REF:JG-01
25 March 2022

The following is a review of a report entitled “Subsidence prediction report for the Meadowbrook Underground Project” prepared by Gordon Geotechniques Pty Ltd in March 2022. It is understood that this report is to be used in your EIS submission to the Queensland Government.

Figure 1 Geotechnical model for longwall fracturing and how it relates to physical models.

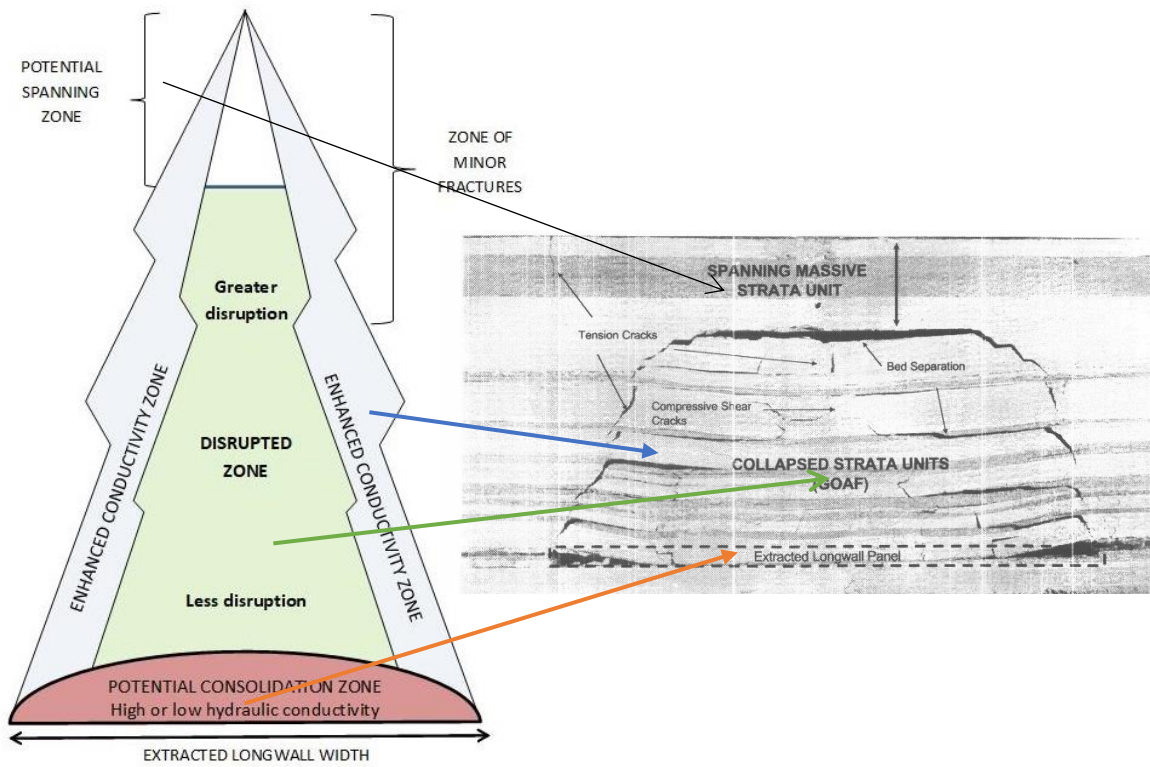
Working in the Bowen Basin, Seedsman (2019, 2020) developed an alternative model for longwall fracturing based on geotechnical engineering considerations. I concluded that if the vertical subsidence at the surface is supercritical then there will be a fracture connection all the way to the seam. This connection, referred to as the Enhanced Conductivity Zone (ECZ), will have very high conductivity closer to the seam (level of the Caved zone) and decrease with height above the seam unless there is a spanning unit present. A transient ECZ is present ahead of, and parallel to, the longwall face and this will have much higher hydraulic conductivities than the ones that form along the sides of the extraction. The hydraulic conductivity will decrease as the longwall face passes as the goaf pile develops. If the roof rocks are moisture sensitive the caved zone may reconsolidate and its conductivity drop to very low levels. The strata in the disturbed zone, although they have moved downwards, retain their overall bedding structure and have a relatively low hydraulic conductivity.

An implication of this model is that groundwater analysis should include consideration of the possibility of a low conductivity fracture connection to the surface. I note that the Gordon Geotechnics report recognises this possibility (page 50) and that this scenario has been considered in the groundwater report.

Figure 2 Chart to estimate average hydraulic conductivity as a function of height above seam and maximum vertical subsidence (original data digitised from Gale 2008)

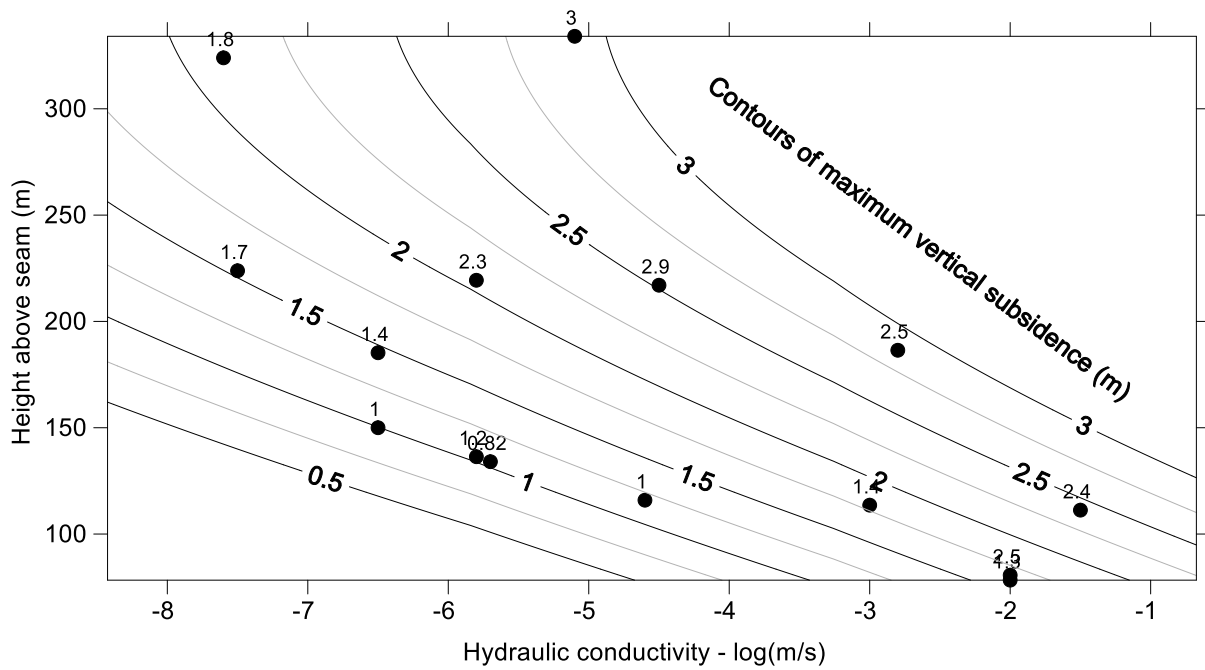
To date, hydraulic conductivity values have not been allocated to the Seedsman (2019) model. In the interim and subject to critical hydrogeological review, it may be possible to use the following chart to estimate values. This chart is simply a re-plotting of the data in Figure S1 of Gale (2008). For the predicted subsidence at Meadowbrook of 2.5 m, this chart indicates that the hydraulic conductivity of the near surface rocks will be in the order of 10^{-6} m/s, which is likely to be 1 or 2 orders of magnitude lower than the likely pre-mining values.
